Report #: 2510-5288

Review and Discussion of Foothills Nature Preserve Improvements Project Scope Reduction

FOOTHILLS NATURE PRESERVE IMPROVEMENTS PROJECT REDUCED SCOPE EXHIBIT

FOOTHILLS NATURE PRESERVE IMPROVEMENTS

DESIGNATED PEDESTRIAN PATHWAYS

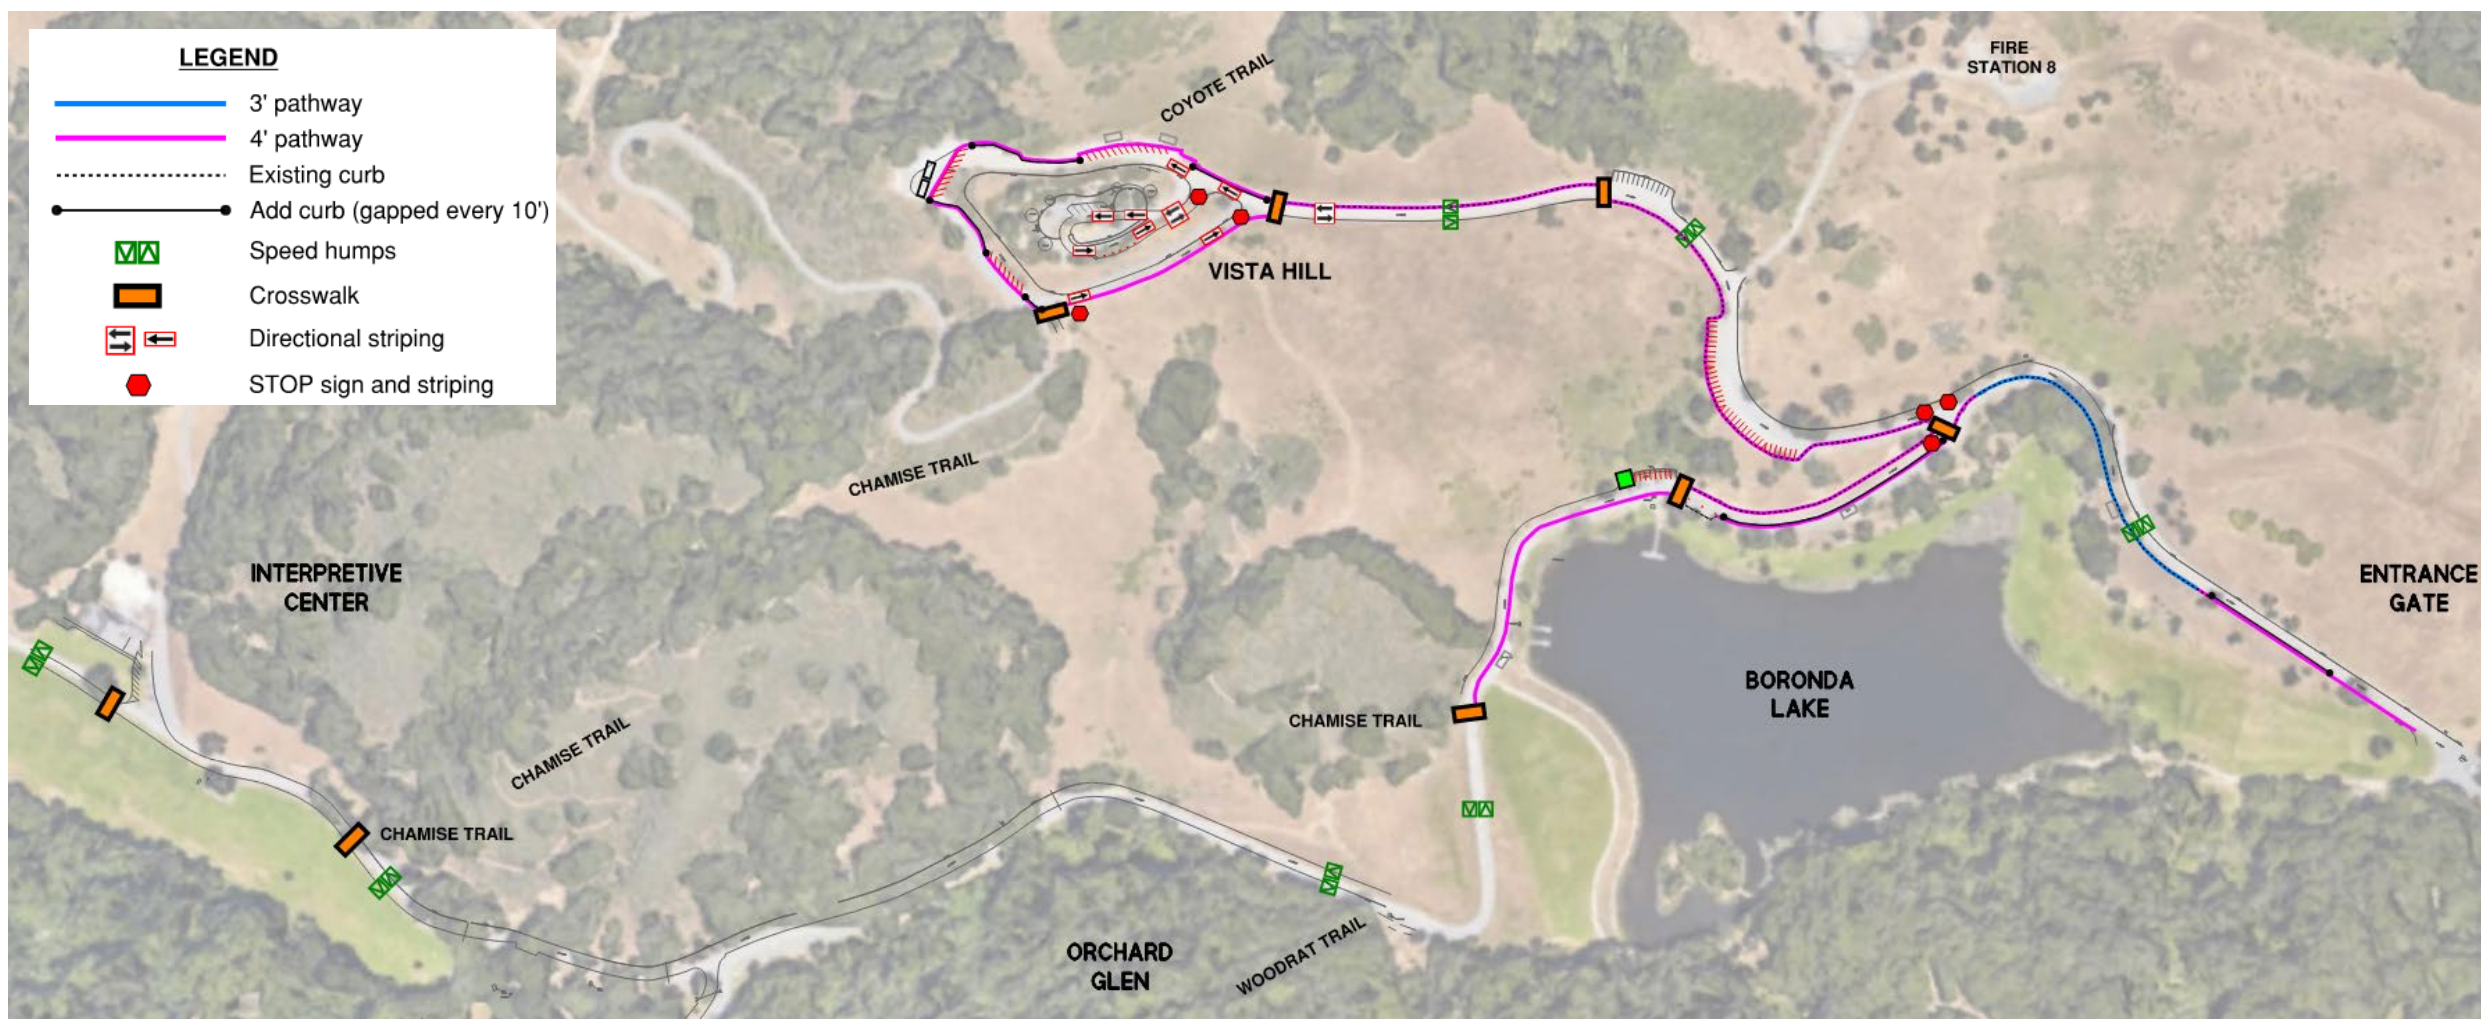
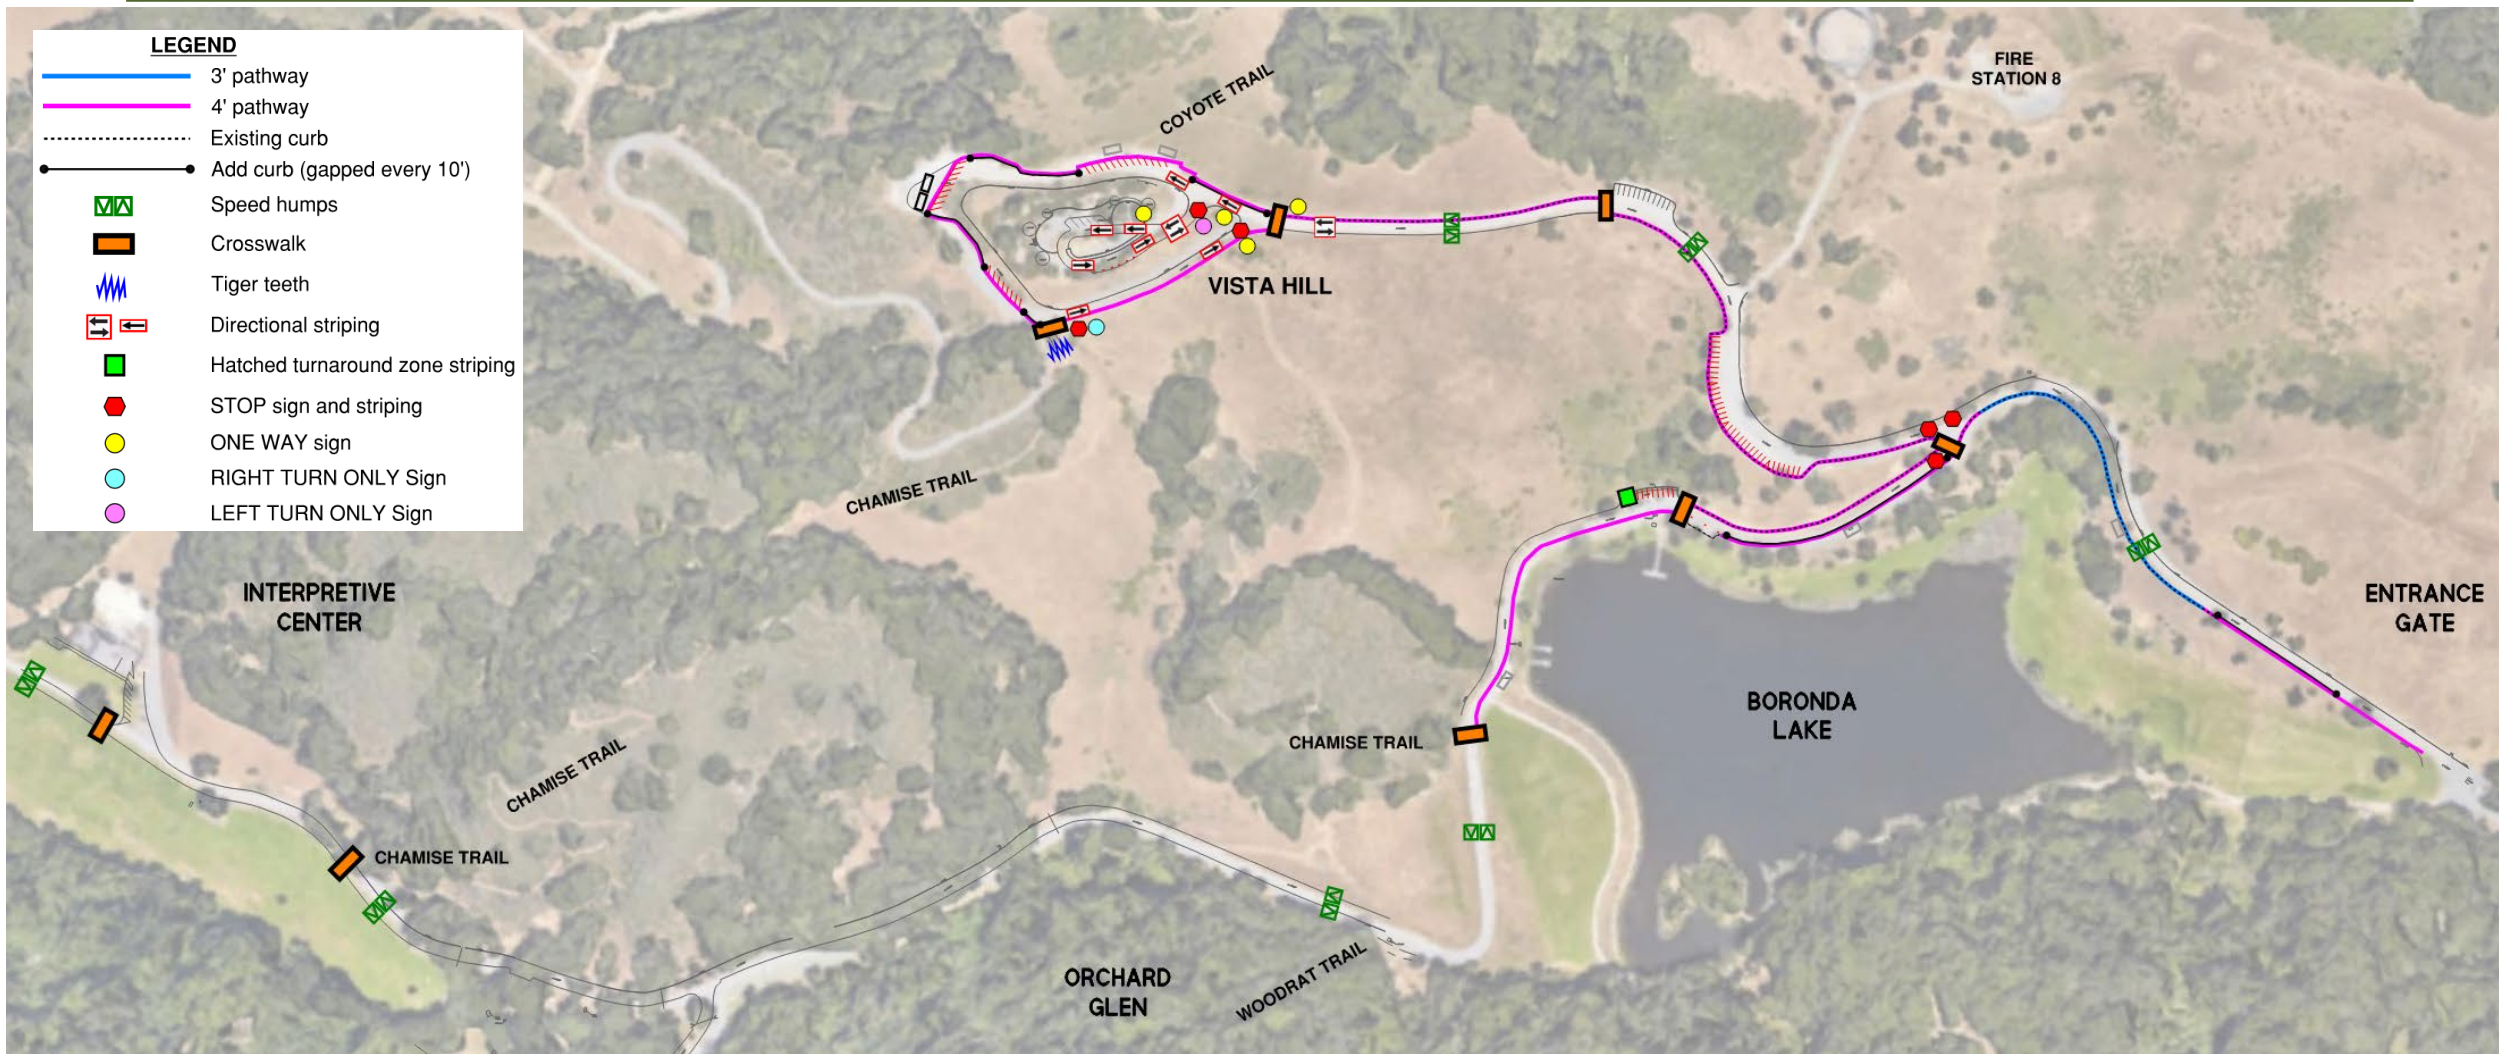
- 3- or 4-feet wide pathways.
- Quarry fines material.
- Utilize existing boulders as safety barrier where feasible.
- Asphalt curb to provide a safety barrier where existing boulders are not feasible.
- No tree removals, gaps in pathway where necessary.

PARKING IMPROVEMENTS

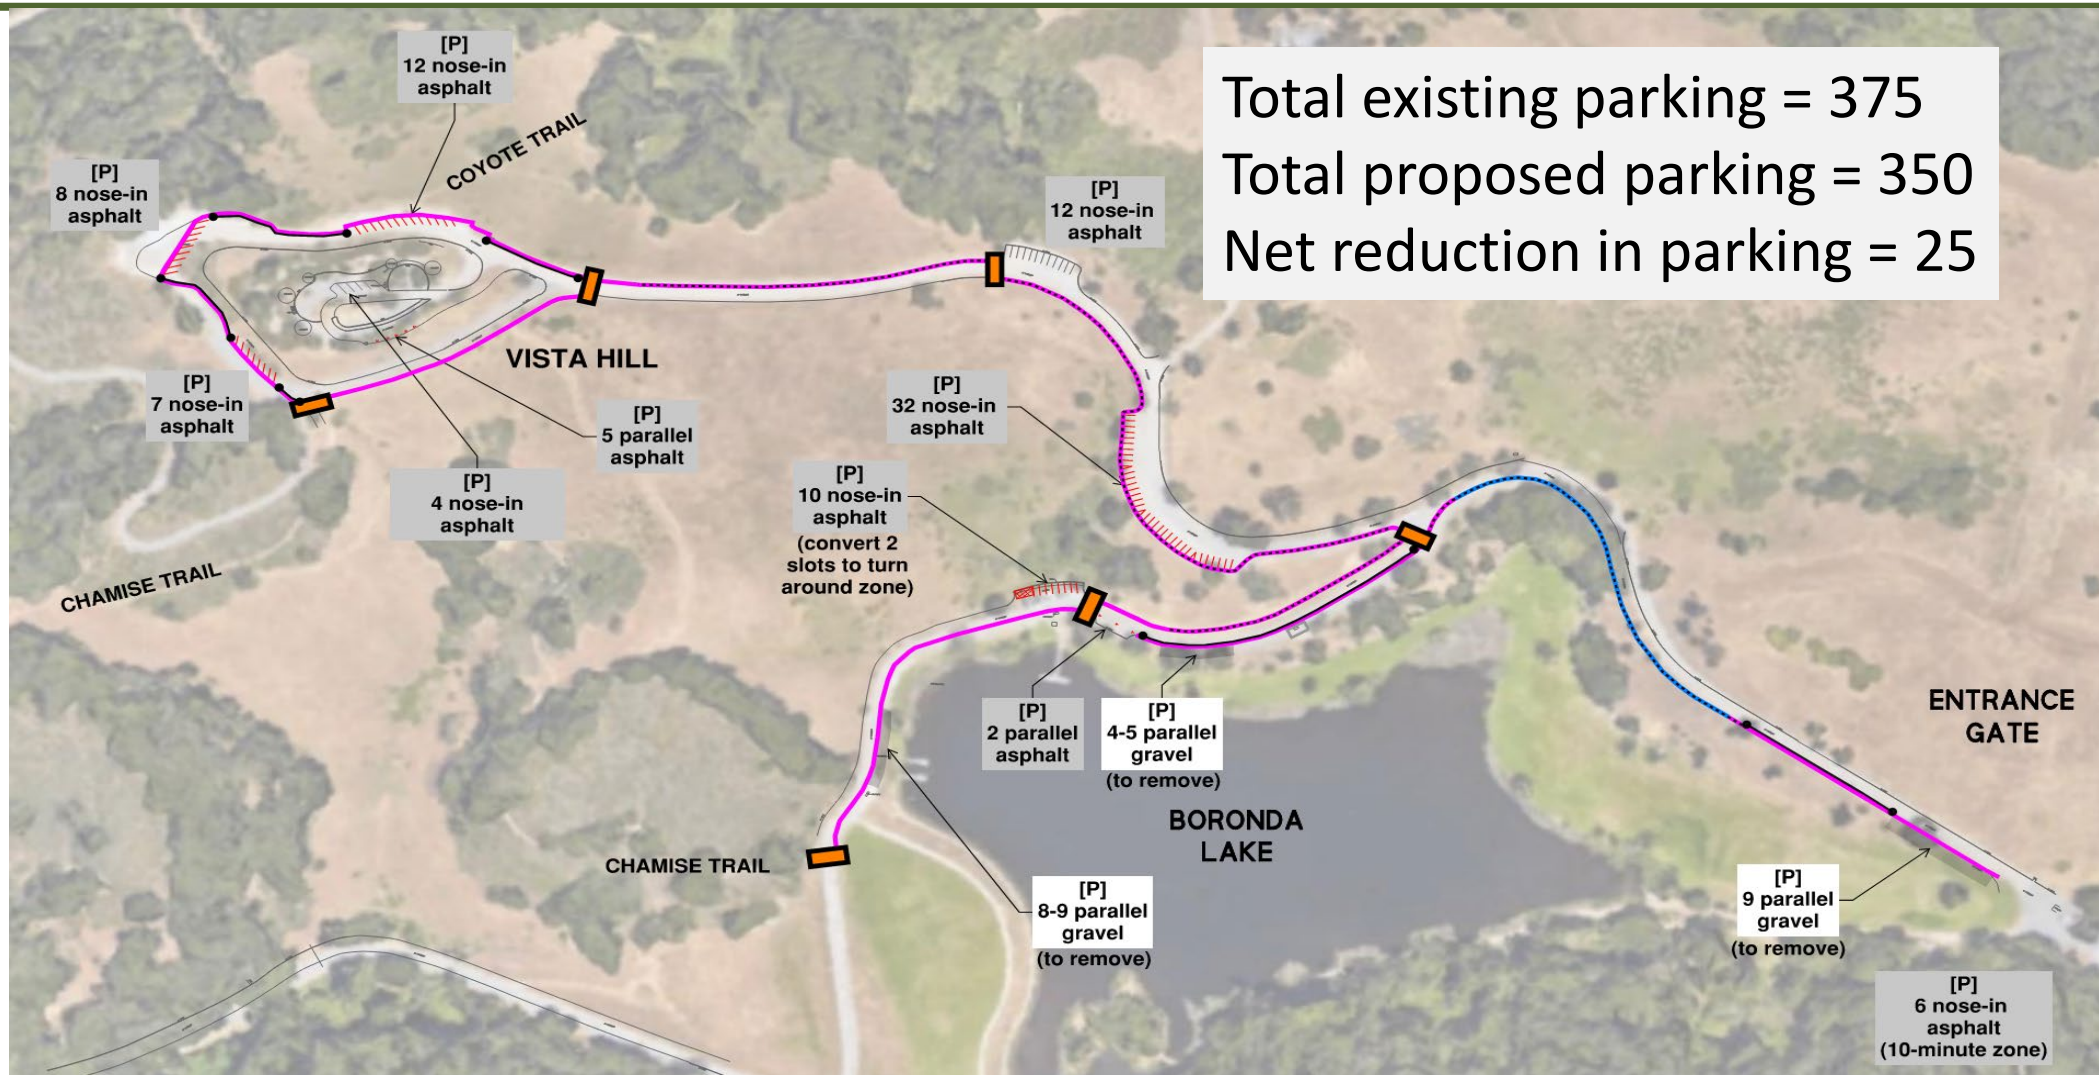
- No new hardscaped parking lots.
- Parking reconfiguration with striping at Vista Hill and Boronda Lake areas.
 - Traffic flow and efficiency
 - Clearly delineate parking
 - Removal of excess asphalt surfacing at Vista Hill

Some parallel parking will be removed to accommodate new pathways and to provide safer and efficient space.
